METROPOLITAN GOVERNMENT OF NASHVILLE AND DAVIDSON COUNTY

STAFF RECOMMENDATION
404 Taylor Street
July 16, 2014

Application: New construction – addition; Setback determination
District: Germantown Historic Preservation Zoning Overlay
Council District: 19
Map and Parcel Number: 08209009300
Applicant: Jeff Zeitlin, Developer
Project Lead: Sean Alexander, sean.alexander@nashville.gov

SITE PLAN

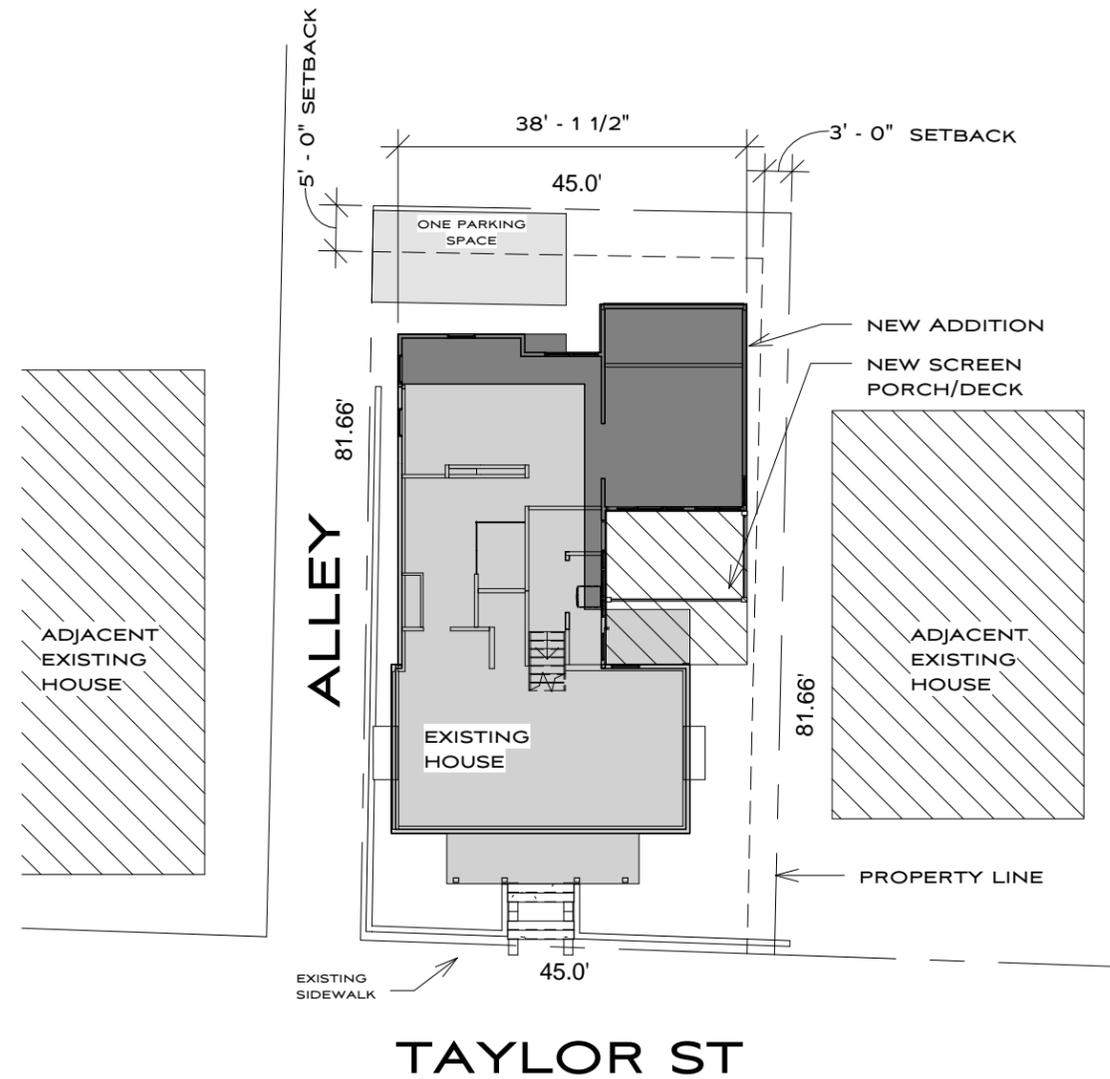
The addition will be flush with the left side of the existing house, which has a three foot (3') side setback. In going wider on the right side, the edge of the addition will sit four feet (4') from the right side property line. The rear setback of the addition will be ten feet (10'), whereas the standard minimum rear setback is twenty feet (20'). However, Staff finds that the proposed setbacks are appropriate because the lot is unusually shallow, and it will be in keeping with the historic character of the area. Staff finds the proposal to meet guidelines 2.1.3. and 2.2.1.

DEMOLITION PLAN

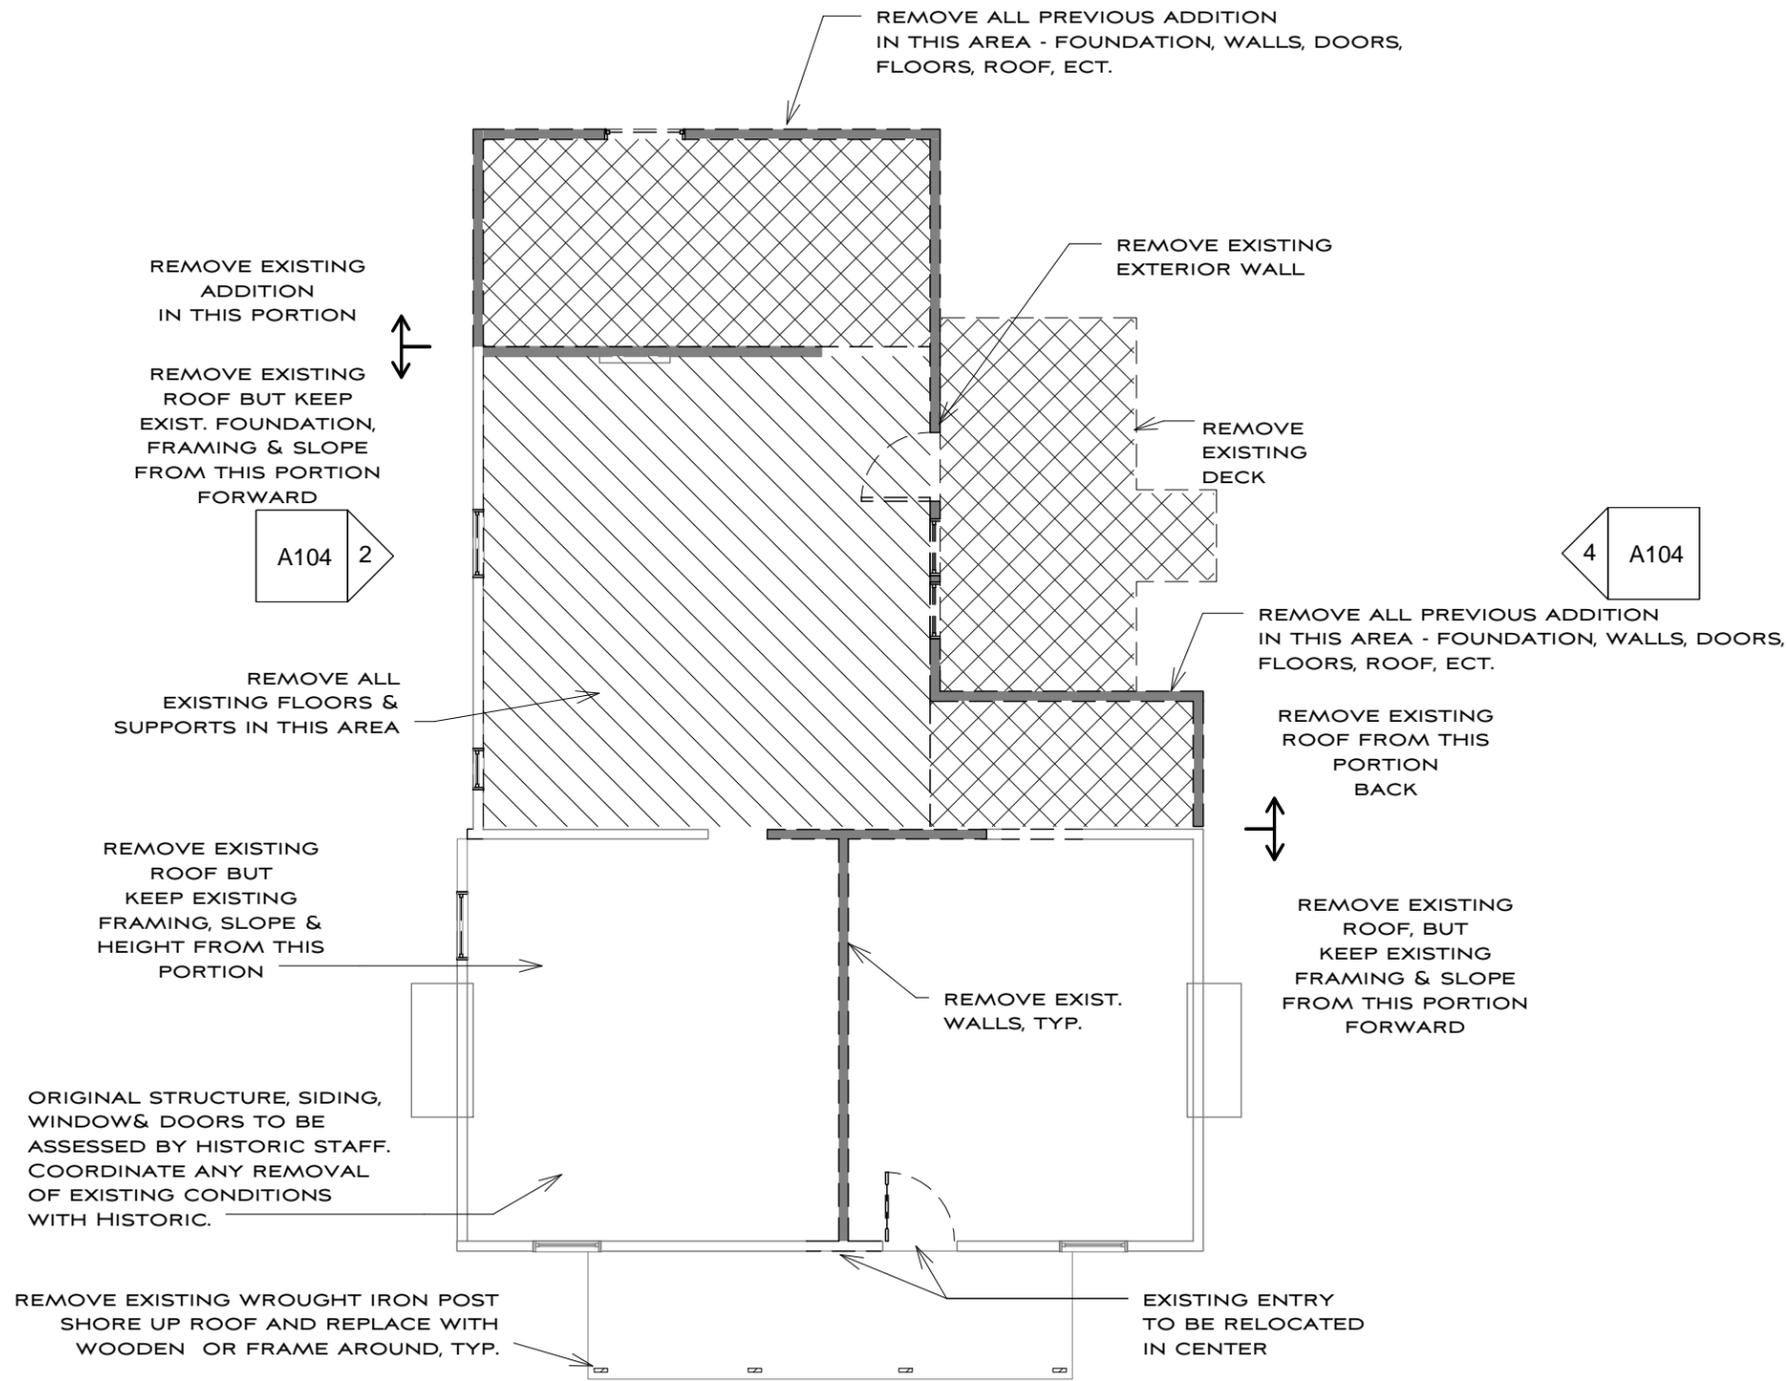
The more recent rear addition will be partially demolished and reconstructed. (See “post-1957 addition” in the image on page 13.) Because this portion of the structure does not contribute significantly to the historic character of the house and the neighborhood, its demolition meets guideline 7.2.2.

A7

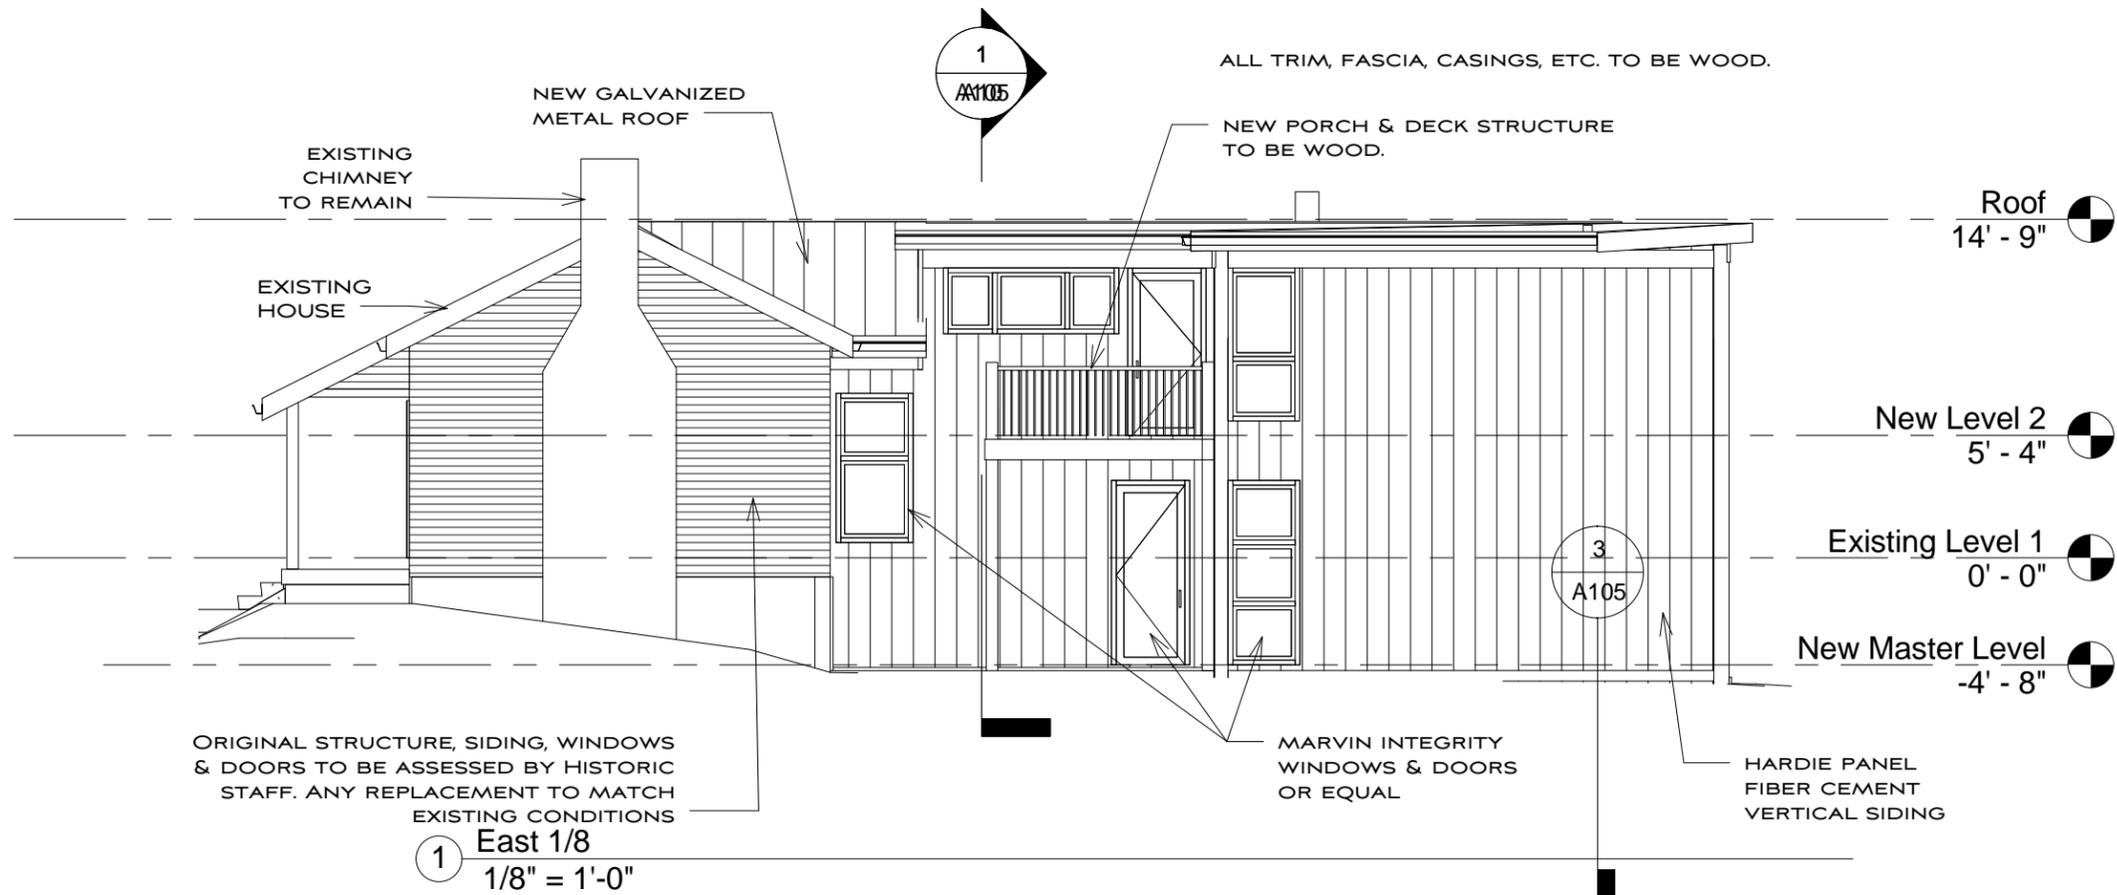
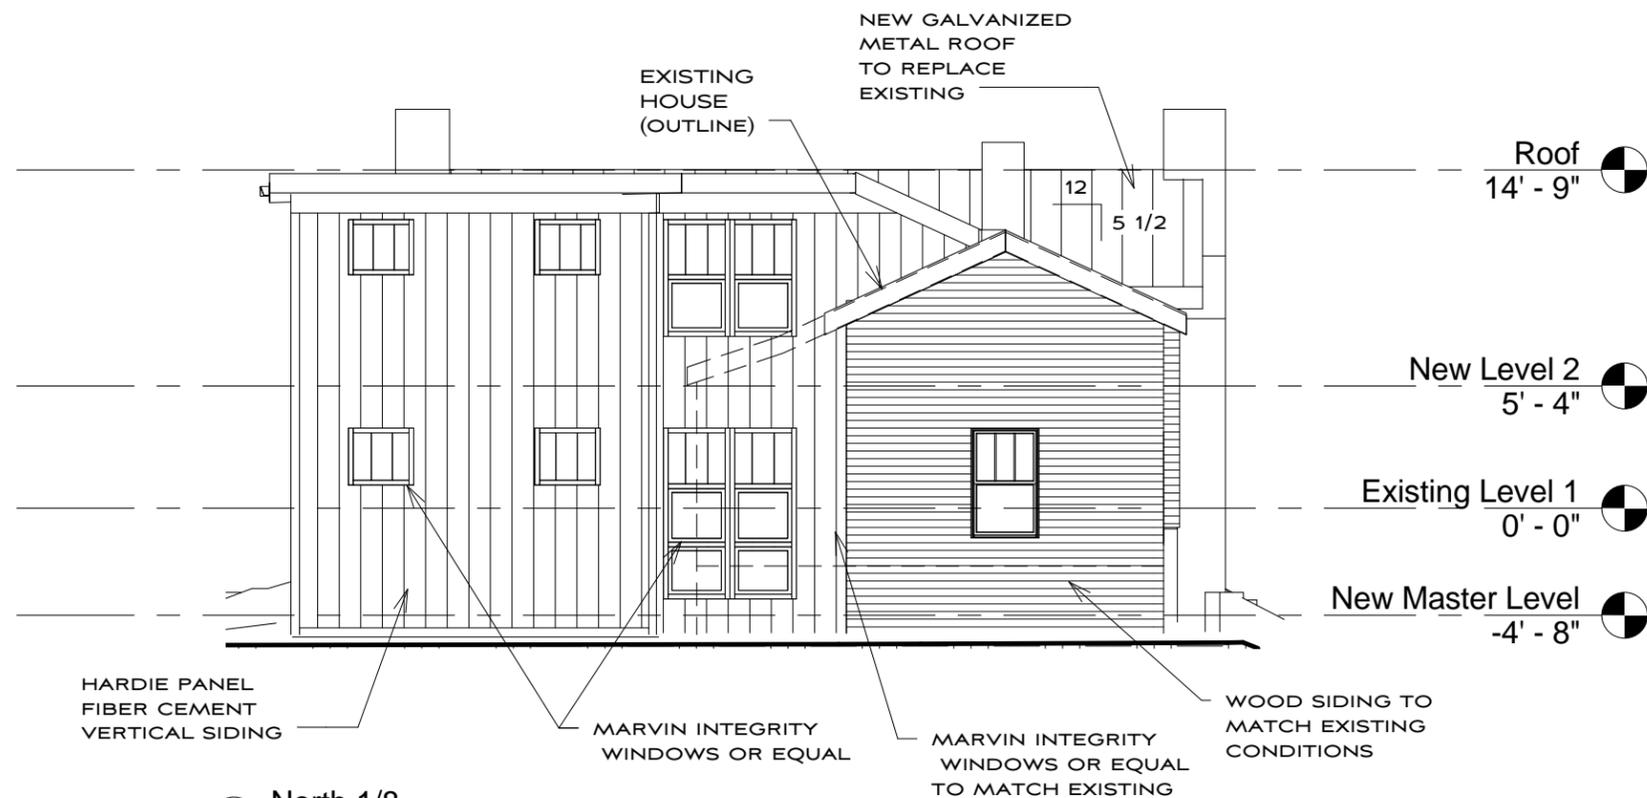
At the ridge of the pre-1897 rear wing, the roof of the addition will start out flat toward the center of the structure, then pitch up and flatten out again at the height of the original side-gabled ridge. By having a flat roof, and by lowering the floor level inside the rear wing down nearly to grade-level, the interior of the addition will gain a second story without going taller than the roof of the original house. Staff finds that the height of the flat roof of the addition, matching the height of the historic house, is appropriate. Although the pitched portion of new roof connecting the pre-1897 rear wing to the flat roof would not alter the historic eave and ridge heights, it is not sufficiently separated from the existing structure and will read as an inappropriate change to the appearance of the historic structure. It will have the perception of increasing the height of the house which is typically only allowed when the additional height takes place far back from the street facing façade. The project does not meet section 4.2.3.

The addition will extend across the width of the structure and out six feet (6') wider than the historic house on the right side. This wider portion will be two stories tall, but the first story will be separated from the rear corner of the historic house by seven feet (7') and the upperstory will sit back an additional ten feet (10'). By setting the addition back in this way, the visual impact of the addition will be reduced and it will not obscure or destroy historical or architectural features.

The addition will have wood clapboard siding on the side and rear of the left wing, matching the profile and exposure on the original structure. The two-story component will have vertical cement-fiberboard siding. The existing asphalt shingle roof will be replaced with metal 5v-crimped roofing, which is an appropriate material for a house of this age and character. The color of the roof is not known, and would need to be approved by Staff. The flat roof of the two-story component will have an EPDM roof. The windows and doors on the addition will be wood, Marvin Integrity windows, matching the material and design of the existing windows. The trim and materials of the front and rear porch columns and railings will be wood. Staff asks that the porch columns have caps and bases, as these were typical of historic houses. Staff finds these materials to be appropriate and to meet guideline 2.4.

The proportion and rhythm of windows and doors on the original structure and the pre-1897 addition appear to have been altered. Upon removal of the vinyl siding, staff recommends that the structure should be inspected to see if the original fenestration pattern is evident underneath. The existing location and proportions could be retained, or it would also be appropriate to restore original fenestration. The windows on the left side and rear of the new addition will be wood to match the existing windows, and will match the proportions as well. The rhythm and proportion of doors and windows on the two-story component will be more contemporary, in keeping with the character of that part of

- The original siding, doors, and windows to be assessed by Staff and approved for repair or replacement as necessary.
- The porch columns have caps and bases.
- The color of the roof is approved by Staff.
- The new roof be more clearly separated from the ridge of the pre-1897 rear wing.
